# Transition to Step 1 and New Package Substrate for Select Virtex-5 LXT and SXT Devices

XCN07026 (v1.0.1) March 11, 2008

Product/Process Change Notice

Figure 1: Example Top Mark

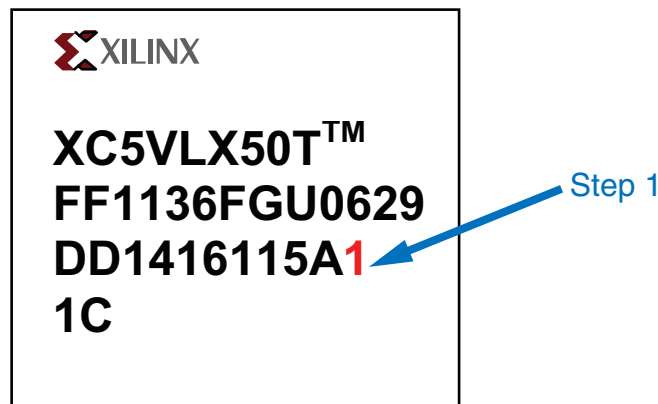
Step 1 devices can be visually identified by the additional "1" at the end of the third line of the package top mark (see Figure 1).
